**HOLTEC INTERNATIONAL**  
**HI-STORM 100 CASK SYSTEM**  
**AMENDMENT NO. 1**  
**SAFETY EVALUATION REPORT**

Figure 4.1 The effect of thickness reduction due to oxidation of the PWR cladding on the stress.

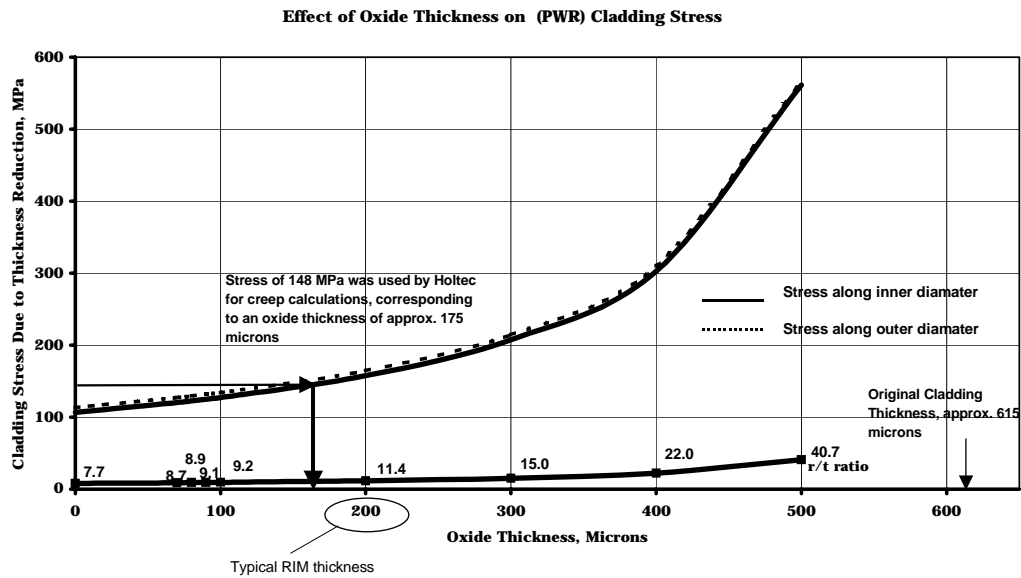
For the PWR fuel cladding, for an internal pressure of 2,000 psi at the start of storage, a radius to thickness ratio of 10.5 was used to determine the cladding stress of 144.7 MPa. Staff has

determined that this value corresponds to an oxide thickness of approximately 175 microns, as shown in Figure 4.1.

Thus, by eliminating the oxide outer layer, the applicant uses a higher stress value for the cladding, as if approximately 175 microns of oxide layer has been removed from the total metal thickness. Considering that the experimentally verified (Figure 4.A.13 in Appendix 4-A of the Holtec SAR) cladding oxide thickness varies between 100 to 140 microns at a burnup of 60 GWd/MTU, the staff has concluded that the applicant's approach has included reasonable conservatism in its analyses.

Figure 4.2 The effect of thickness reduction due to oxidation of the BWR cladding on the stress.

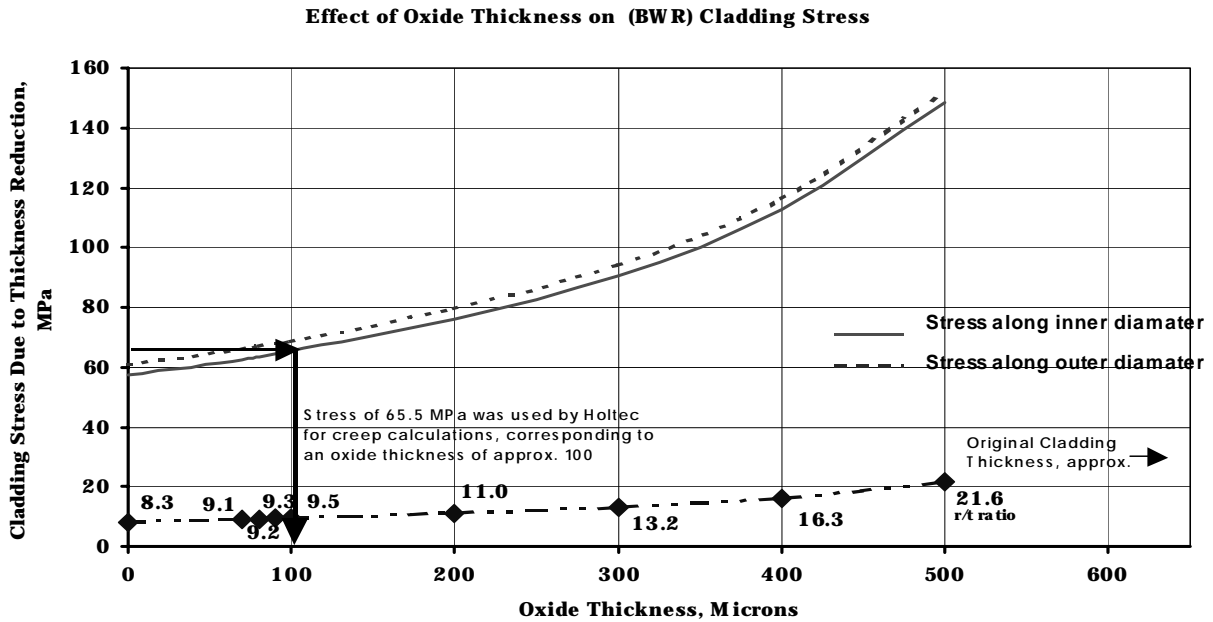
For the BWR fuel cladding, for an internal pressure of 1,000 psi at the start of storage, a radius to thickness ratio of 9.5 was used to determine the cladding stress of 65.5 MPa. Staff has determined that this value corresponds to an oxide thickness of approximately 80 microns, as shown in Figure 4.2. Thus, by eliminating the oxide outer layer, the applicant uses a higher stress value for the cladding, as if approximately 80 microns of oxide layer has been removed from the total metal thickness. Experimental data have not been provided for cladding oxide thickness as a function of burnup for the BWR fuel cladding. However, considering the less severe potential for oxidation in BWR, when compared to PWR, the staff has concluded that the applicant's approach has included reasonable conservatism in its analyses.
